**Economic Commission for Europe****Inland Transport Committee****World Forum for Harmonization of Vehicle Regulations****Working Party on Passive Safety****Sixty-second session**

**UN Regulation No. 44 (Child restraint systems)****Proposal for Supplement 14 to the 04 series of amendments  
to UN Regulation No. 44 (Child restraint systems)****Submitted by the expert from France\***

The text reproduced below was prepared by the expert from France on behalf of the Technical Services Group (TSG) on Regulation No. 44 concerning the correct use of the Y symbol for the use of a crotch strap. The modifications to the current text of the UN Regulation are in strikethrough for deleted characters.

#### Arrangements of the approval marks

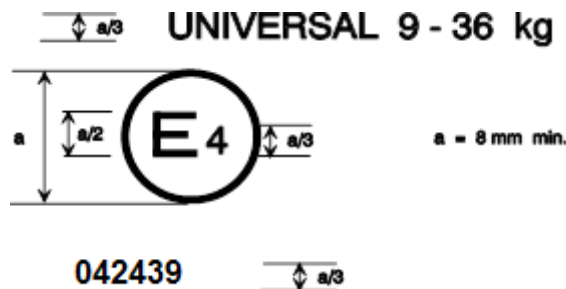
The child restraint system bearing the above approval mark is a device not capable of being fitted in every vehicle and of being used for the 9 kg-25 kg mass range (Groups I and II); it is approved in the Netherlands (E 4) under the number 042450. The approval number indicates that the approval was granted in accordance with the requirements of the Regulation concerning the approval of restraining devices for child occupants of power-driven vehicles ("child restraint system") as amended by the 04 series of amendments. ~~The symbol "Y" indicates that the system contains a crotch strap.~~
